State of Alaska
Department of Fish and Game
Sportfish Division

Nomination Form
Anadromous Waters Catalog

Name of Water Body Davis Creek (whole drainage) USGS Name Local Name (page 2)
 Addition Deletion Correction Backup Information

AWC Nom #25-594

Nom # 25-594 Map # 1

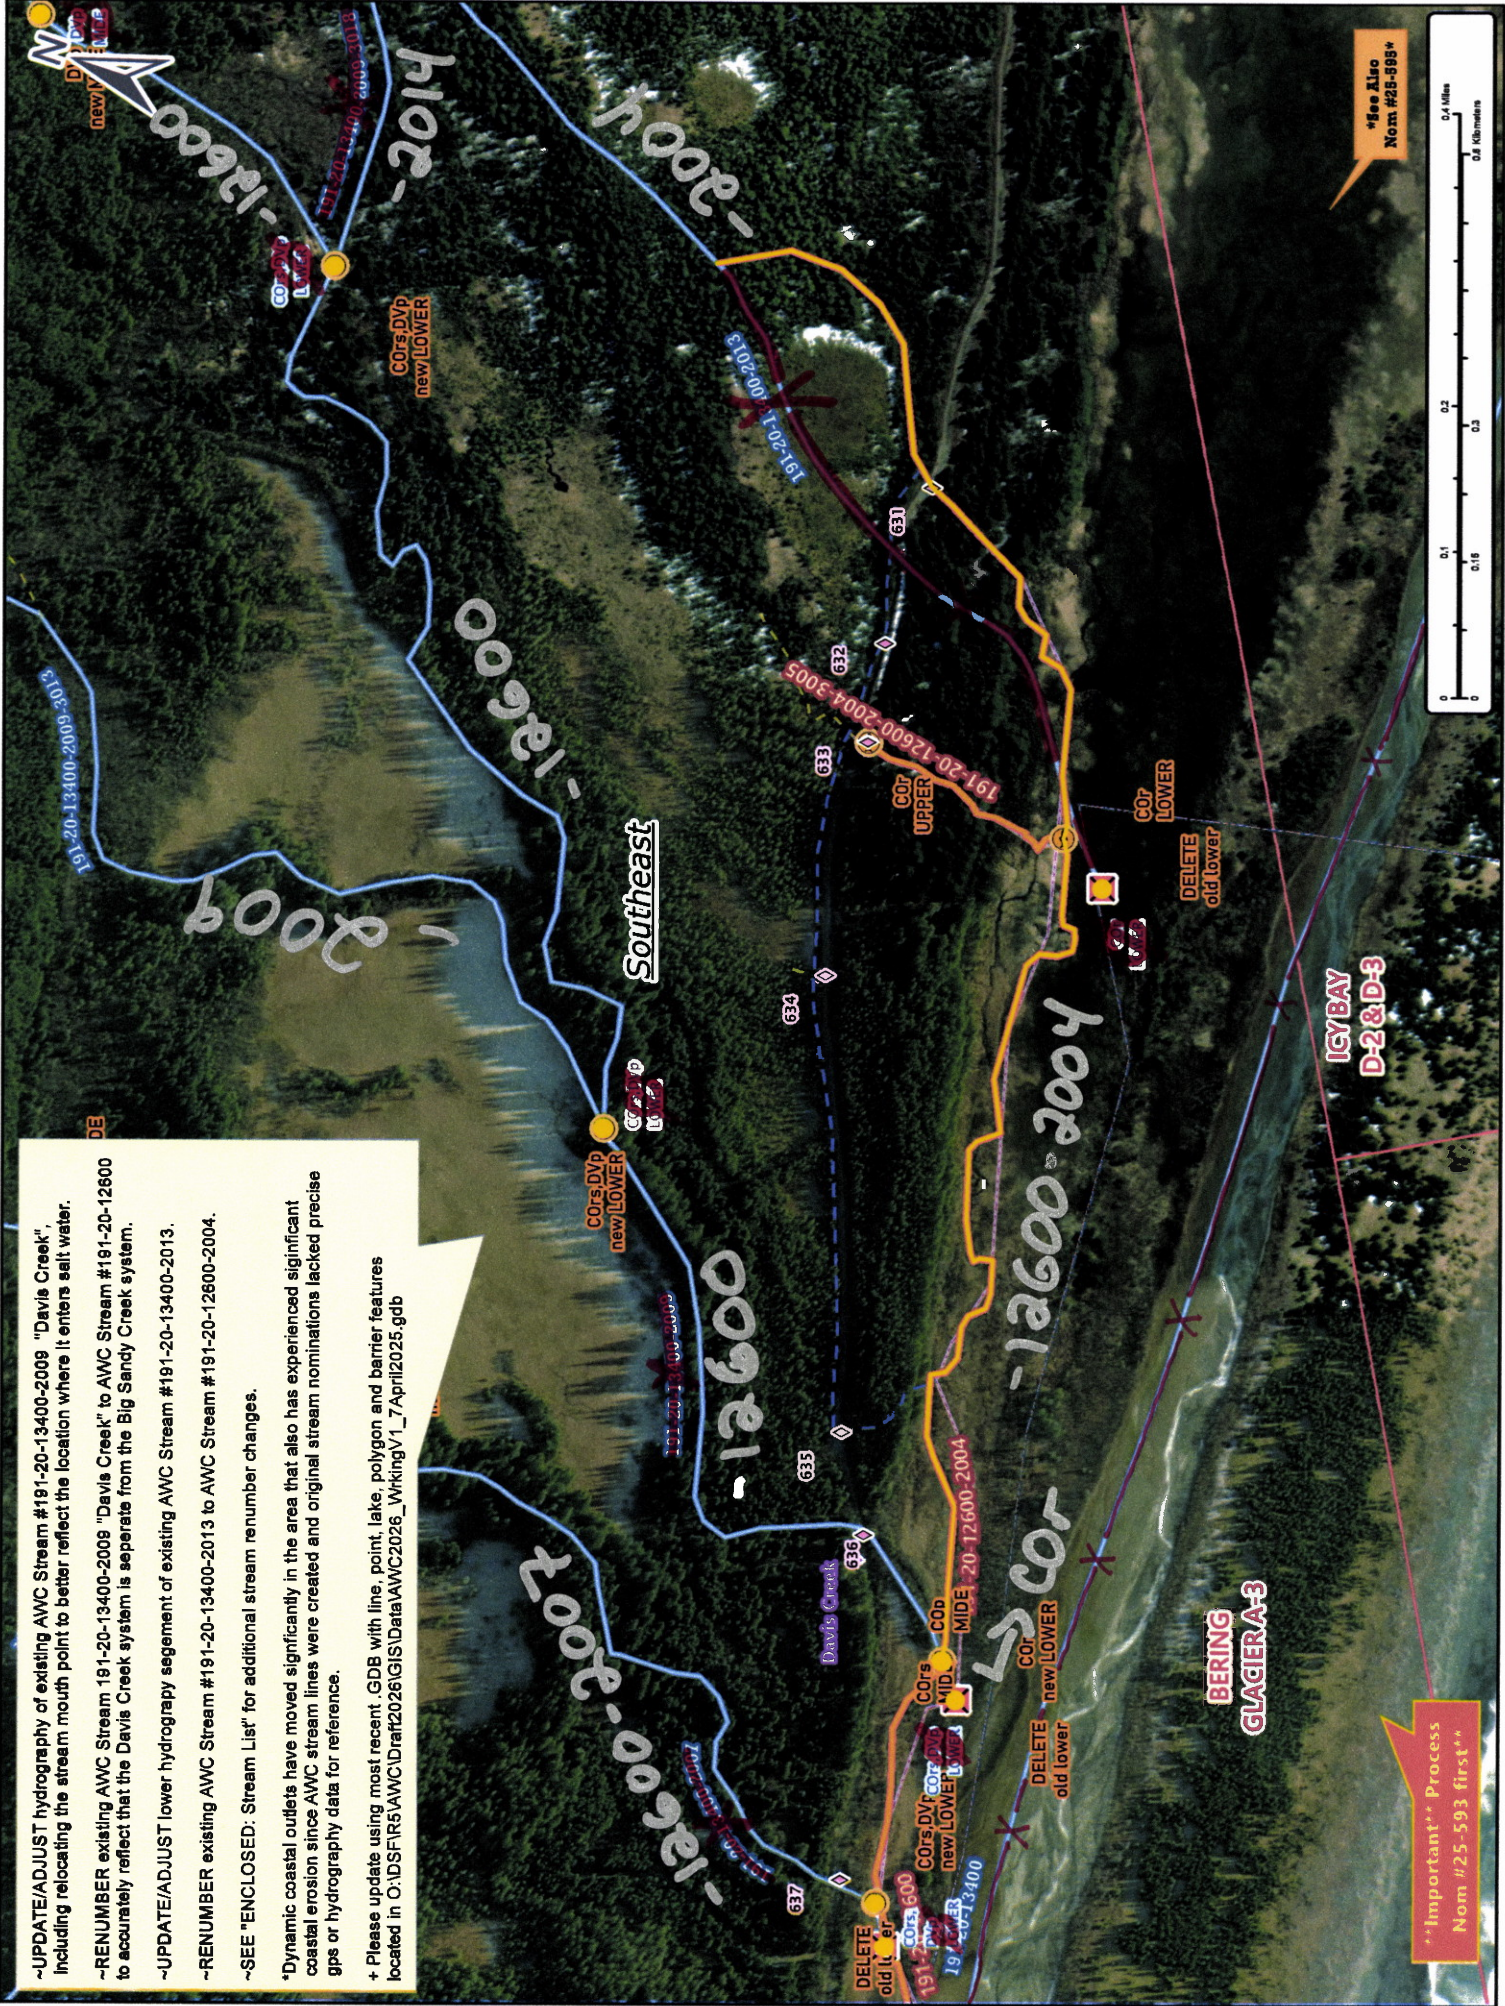
~UPDATE/ADJUST hydrography of existing AWC Stream #191-20-13400-2009 "Davis Creek", including relocating the stream mouth point to better reflect the location where it enters salt water.

~RENUMBER existing AWC Stream 191-20-13400-2009 "Davis Creek" to AWC Stream #191-20-12600 to accurately reflect that the Davis Creek system is separate from the Big Sandy Creek system.

~UPDATE/ADJUST lower hydrography segment of existing AWC Stream #191-20-13400-2013.

~RENUMBER existing AWC Stream #191-20-13400-2013 to AWC Stream #191-20-12600-2004.

~SEE "ENCLOSED: Stream List" for additional stream renumber changes.

*Dynamic coastal outlets have moved significantly in the area that also has experienced significant coastal erosion since AWC stream lines were created and original stream nominations lacked precise gps or hydrography data for reference.

+ Please update using most recent GDB with line, point, lake, polygon and barrier features located in C:\NDS\FIR5\AWC\Draft2026\GISData\AWC2026_WorkingV1_77April2025.gdb

Map # 4

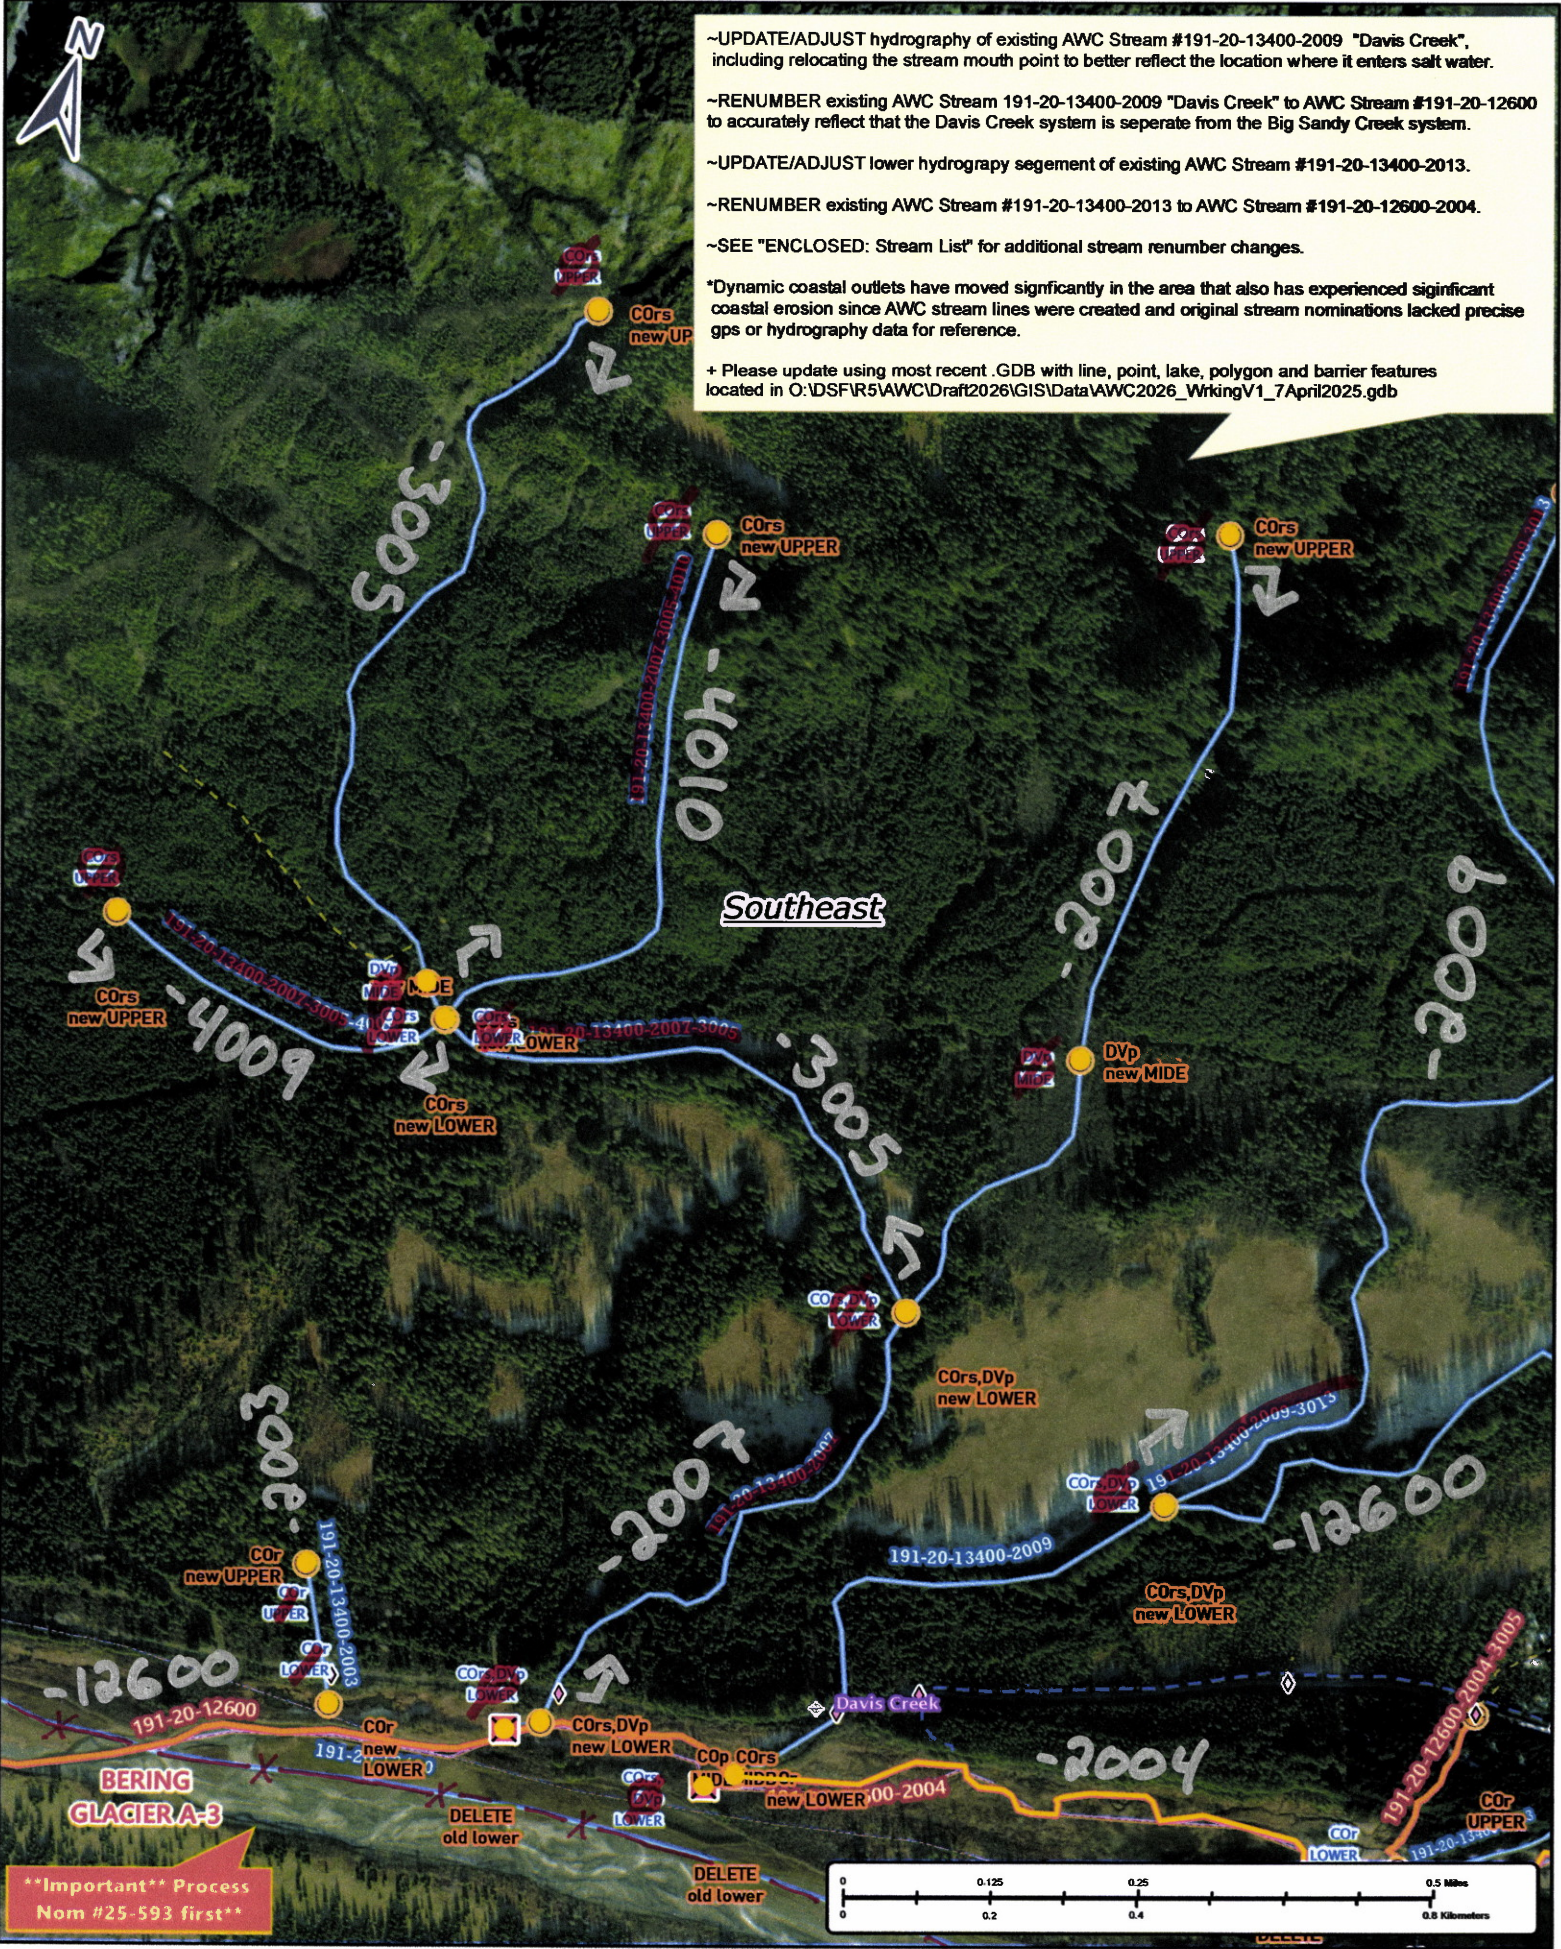
~UPDATE/ADJUST hydrography of existing AWC Stream #191-20-13400-2009 "Davis Creek", including relocating the stream mouth point to better reflect the location where it enters salt water.

~RENUMBER existing AWC Stream 191-20-13400-2009 "Davis Creek" to AWC Stream #191-20-12600 to accurately reflect that the Davis Creek system is separate from the Big Sandy Creek system.

~UPDATE/ADJUST lower hydrography segment of existing AWC Stream #191-20-13400-2013.

~RENUMBER existing AWC Stream #191-20-13400-2013 to AWC Stream #191-20-12600-2004.

~SEE "ENCLOSED: Stream List" for additional stream renumber changes.

*Dynamic coastal outlets have moved significantly in the area that also has experienced significant coastal erosion since AWC stream lines were created and original stream nominations lacked precise gps or hydrography data for reference.

+ Please update using most recent .GDB with line, point, lake, polygon and barrier features located in O:\DSF\R5\AWC\Draft2026\GIS\Data\AWC2026_WrkingV1_7April2025.gdb

Map #5

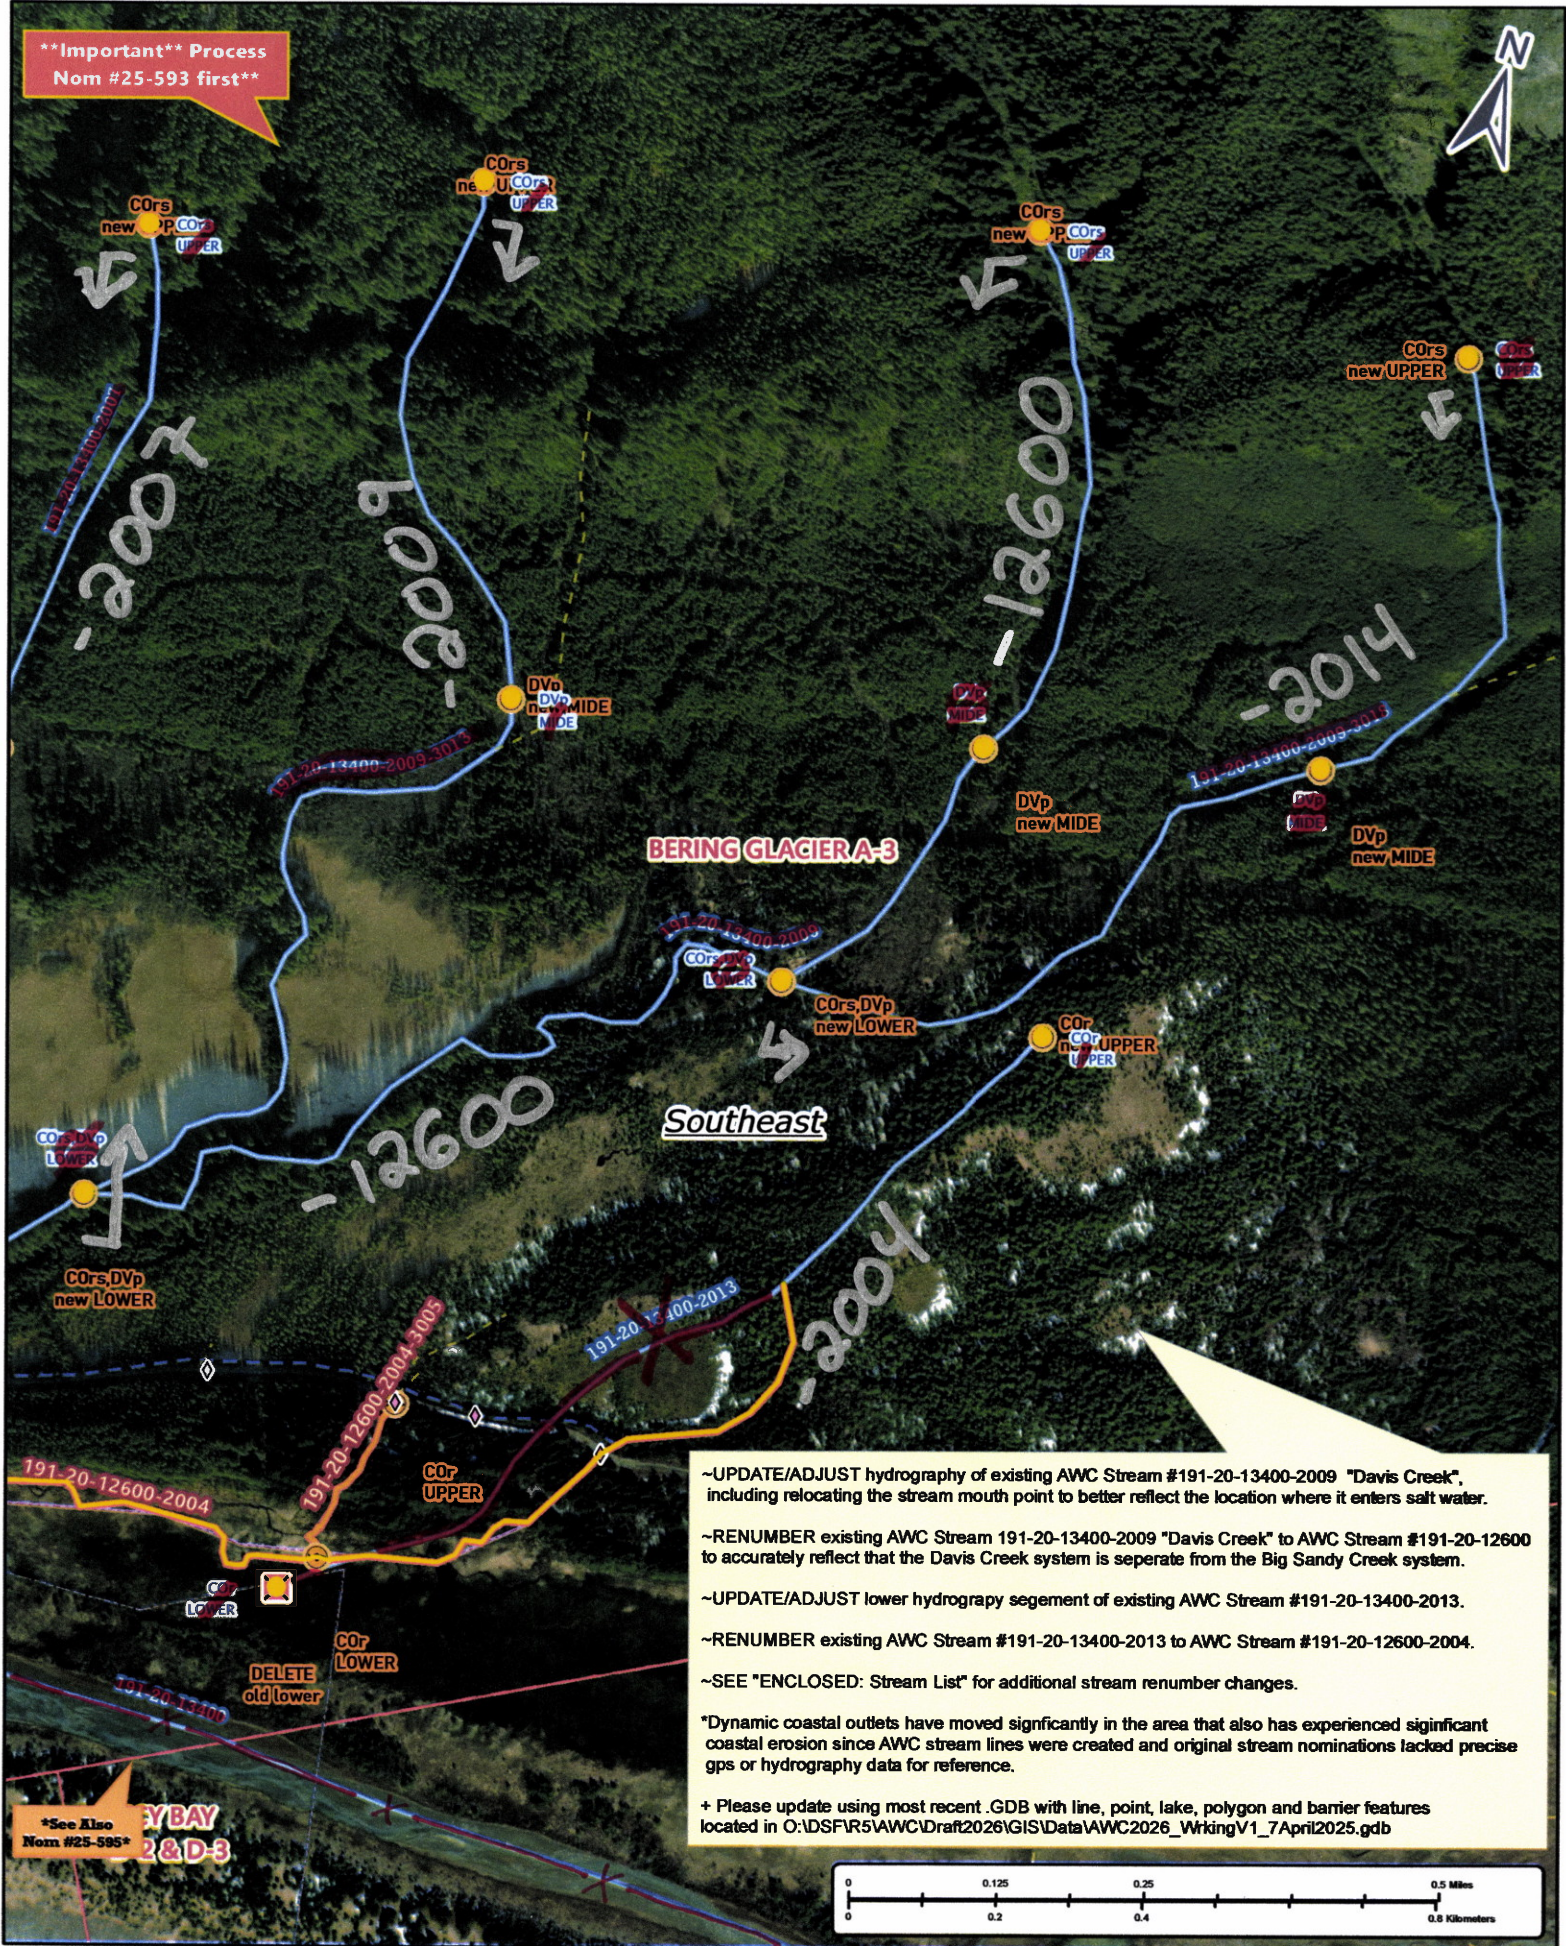
~UPDATE/ADJUST hydrography of existing AWC Stream #191-20-13400-2009 "Davis Creek", including relocating the stream mouth point to better reflect the location where it enters salt water.

~RENUMBER existing AWC Stream 191-20-13400-2009 "Davis Creek" to AWC Stream #191-20-12600 to accurately reflect that the Davis Creek system is separate from the Big Sandy Creek system.

~UPDATE/ADJUST lower hydrography segment of existing AWC Stream #191-20-13400-2013.

~RENUMBER existing AWC Stream #191-20-13400-2013 to AWC Stream #191-20-12600-2004.

~SEE "ENCLOSED: Stream List" for additional stream renumber changes.

*Dynamic coastal outlets have moved significantly in the area that also has experienced significant coastal erosion since AWC stream lines were created and original stream nominations lacked precise gps or hydrography data for reference.

+ Please update using most recent .GDB with line, point, lake, polygon and barrier features located in O:\DSFR5\AWC\Draft2026\GIS\Data\AWC2026_WrkingV1_7April2025.gdb
